ITEM 9.1 DA.2023.0273 - DISCHARGE OF CONDITION 2 (T SHAPED  
SHEDS) - THE ALBION HOTEL - 119 WALLACE STREET  
BRAIDWOOD

ATTACHMENT 1 CONDITION REPORT 119 WALLACE STREET BRAIDWOOD

**CONDITION REPORT**  
**9760**

**SUBJECT PROPERTY**  
119 WALLACE STREET BRAIDWOOD NSW 2622

**Photograph 2**  
Shows the rear or South sides of the West Wing (left hand side) and the East Wing (right hand side)

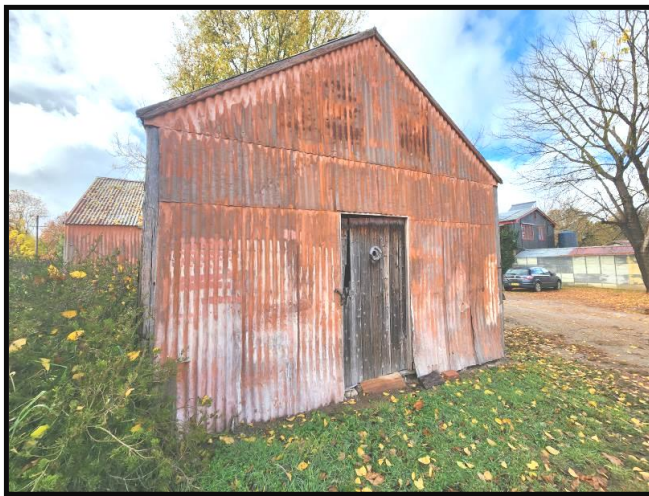
The structures inspected are single level sheds situated at the rear of a commercial property. I will refer to the sheds as 'East Wing' and 'West Wing'. Refer to photographs 1 – 4.
